**SITE PLAN/ARCHITECTURAL REVIEW  
CASE NO. 01-SPR-004 AMENDMENT**

**FOR THE PROPERTY LOCATED AT  
5241 COLODNY DRIVE,  
AGOURA HILLS**

**EXHIBIT A**

*Condominium Project- proposed Remodel  
5241 Colodny Drive*

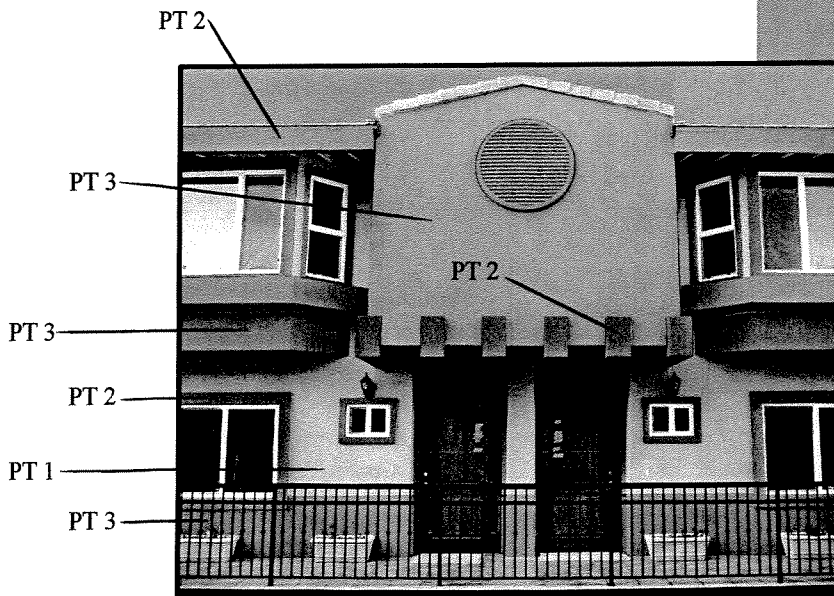
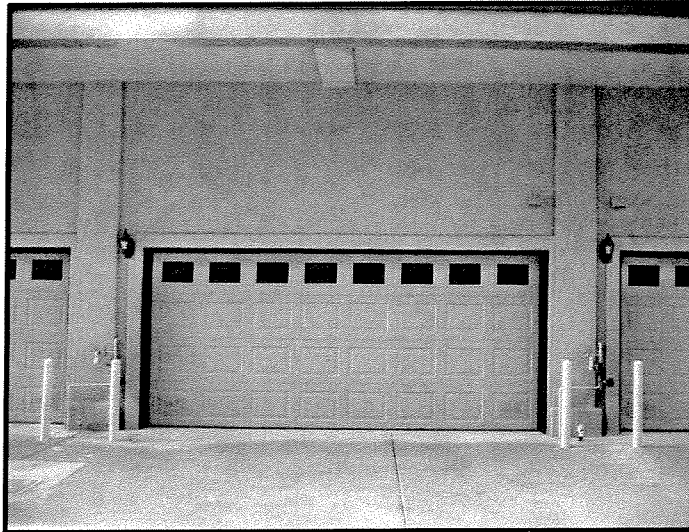
The existing entry facades are sand finish stucco. The articulation of the elevations has sufficient variety of elements to carry the design, with the exception of graphic color.

The proposed coloration concept uses the existing geometries by defining the individual elements with color. The specific color locations are listed on the previous page. It is recommended that these colors are approximate; they should be color tested on the actual building to be reviewed by the Planning Director.

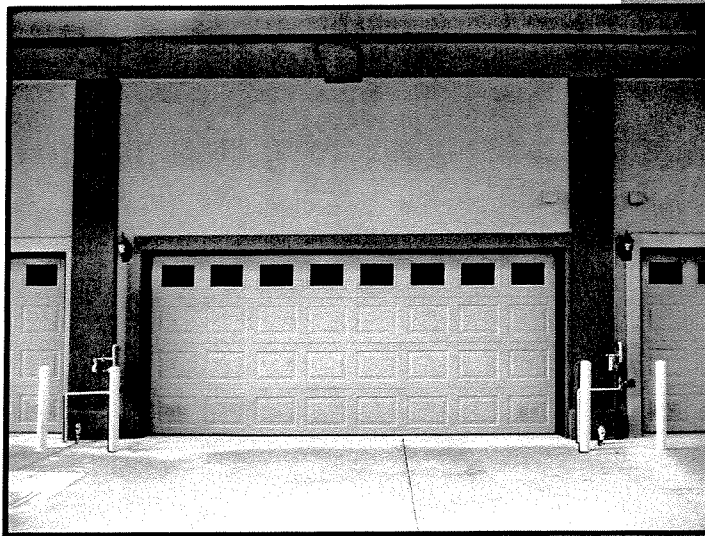
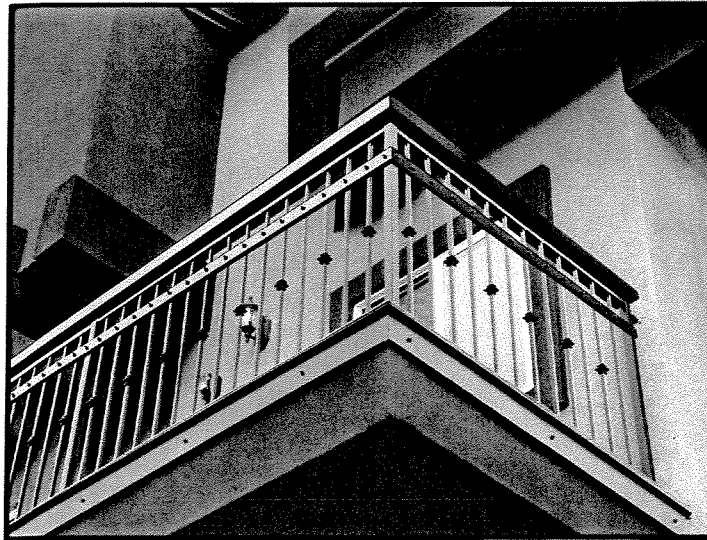
The existing garage door entry areas are constructed of pressed metal roll down doors with a factory paint application to the doors. The jamb and header materials are painted composite plastic finishes. Between each door there is a gas and water access valve at the base. The wall surfaces are sand finish stucco with variegation to the wall as shaped surface treatments. The coloration forms a monolithic appearance to the facade.

The concept for the garage areas is to emphasize the columns by adding a contrasting color to the verticals between the garages. This also enhances the three dimensional quality of the actual parts of the building. The raised frame elements that act as a door surround would also receive color. The undersides of the balconies have a framed coffered edge treatment that will be painted a contrasting color. The interior panel of the coffers will be the adobe color as a contrast to the base stucco color.

*FRONT STAIR DESIGN*

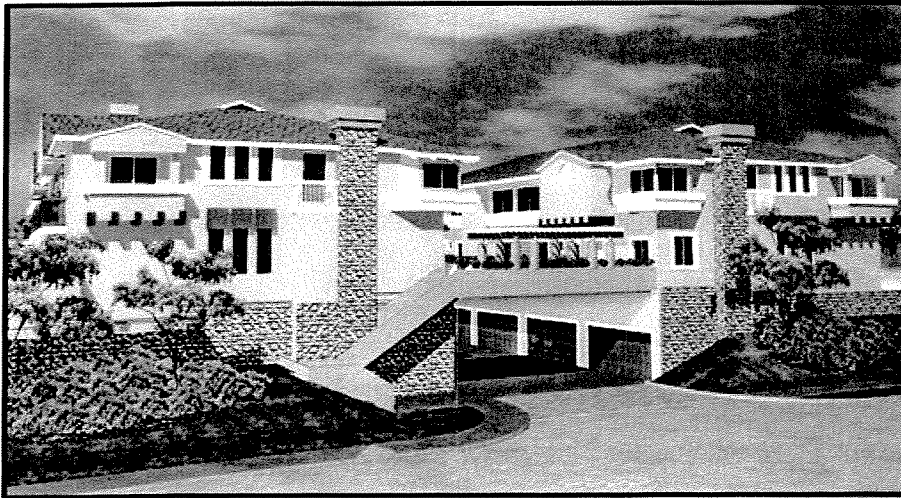
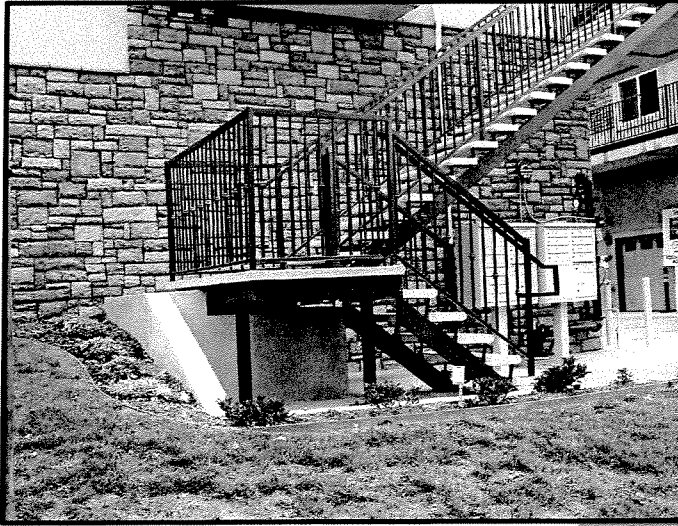
The approved Planning Commission concept plan had a bridge over the entry of the complex with a solid enclosed stair on the left side. In addition there was an Arbor at the bridge, hence the name given for the project the "Arbors". According to the contractor the fire department would not allow a bridge over the entry area as shown on the original concept rendering.

It is proposed that the first flight to the landing be removed and replaced with a faux rock solid base. The handrail to have added elements to the top rail and a additional horizontal rail attached to the vertical members just below the top rail.

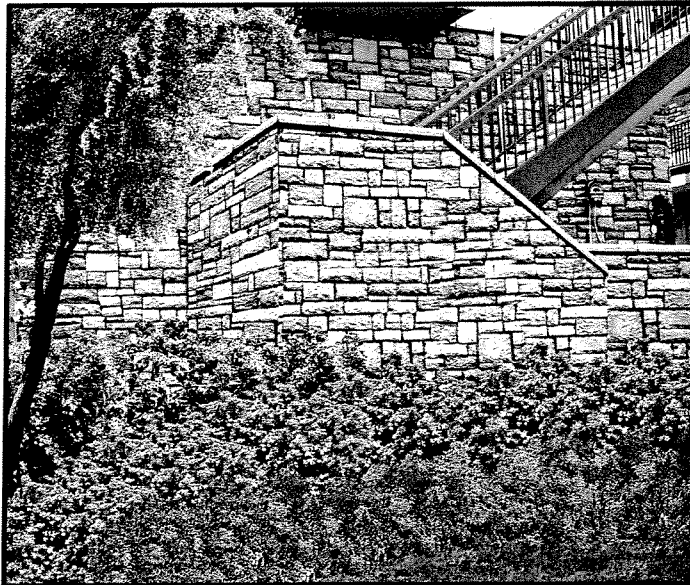
The existing condition is that the stair is a prefabricated metal stair with concrete pan type treads.

The landscaping is not according to the original landscape plans. Some of the plant materials have died and the grass has become weak and does not fully cover the area.

It is recommended that the base of the stairs become a solid rock enclosure. The stairs and the railings to be modified as shown. The top rail is to be added and be larger. An additional rail to be added parallel to the top rail mounted to the vertical rails.

The landscaping is to be further enhanced with healthy plants. Landscaping to be submitted under separate documents.

## *Stair, Column, and Mailbox Concept*

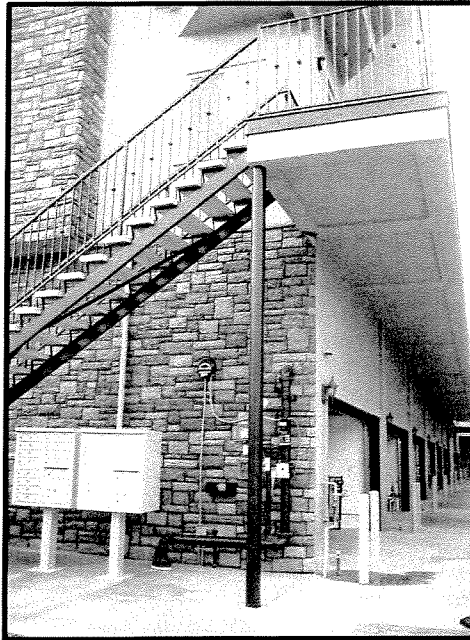
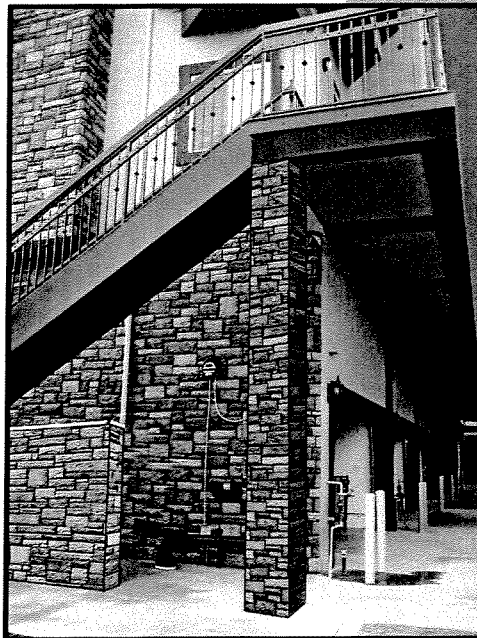
The existing stair is a prefabricated metal stair very common in apartments in the 1960 to 1970's design. The treads are pan construction with concrete treads. There are open spaces between treads.

The mailboxes are the standard post office issue with the face of the boxes facing the street.

The support column is an exposed painted steel round column about 6" in diameter.

The changes to this area would include an additional top rail and a horizontal intermediate rail to the handrail.

The edges of the stair treads would have a solid metal enclosure underneath and to the side of the treads as a solid metal stringer.

The metal column would be encased in a larger column enclosure with faux rock veneer attached to all four faces.

The balcony floor and underside of floor to have contrasting paint color to show the under coffer design that now exists.

The mailboxes would be re-mounted at 90 degrees to the street, back to back with a rock veneer wall in the front, hiding the boxes.

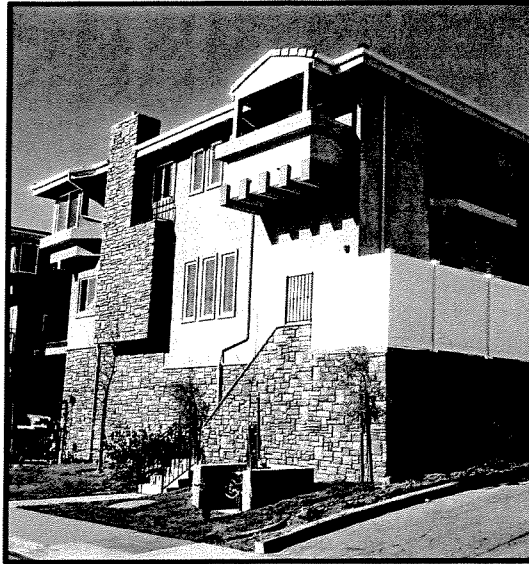
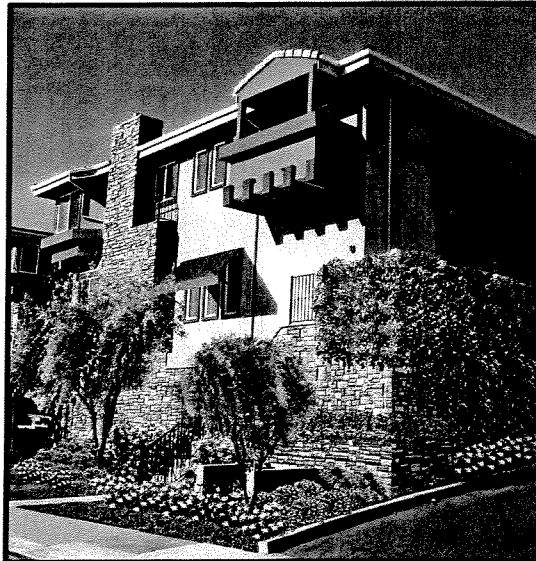
The right side front yard and the street elevation has several components that are problematic. The fence and the retaining wall have too much prominence. The fire sprinkler valves are too visible. The coloration and the facade need further articulation. The landscaping needs to be enhanced.

The fence will need to have a trellis element attached that will allow a living plant material to cover it. The trellis is to be made of a durable pvc plastic rather than wood attached to the fence. Both the fence and the trellis to be painted paint color PT3. A new raised stone planter is to be installed at the base of the fence. Handrails are to be revised to meet the new standard design. Landscaping to be enhanced as shown. Building to be colorized (painted) to new standards. Provide awning above windows as shown.
